NMP-95742

Subject: Nine Mile Point Unit 2 Post Written Examination Activities

ATTACHMENT 9: TEST ITEM APPROVAL/MODIFICATION FOR EXAM BANK

**LC2 99-01 NRC Initial Written Examination
Post-Examination Comments**

RO 78

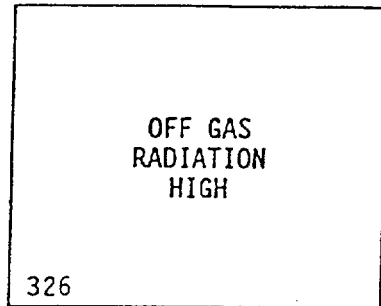
Comment: (enter the comment below)
The question has the wrong answer. The correct answer is "c".

RO 78	SRO 76	<p><i>Tier 2 Group 2</i> <i>K/A 271000, A3.02 - Ability to monitor automatic operations of the Offgas system including: system flows.</i></p> <p>9 of 9 applicants missed the question. 2 RO and 7 SRO applicants selected "c".</p> <p>Plant references were reviewed and BOTH monitors are required to cause the system isolation. The plant procedure referenced for this question was changed in October 1999 to reflect the correct logic configuration. The correct answer is answer "c".</p> <p>The question will be improved by changing the correct answer from "d" to "c".</p>
-------	--------	---

Changes / clarifications made to examination: (provide a description)
Changed the correct answer from "d" to "c".
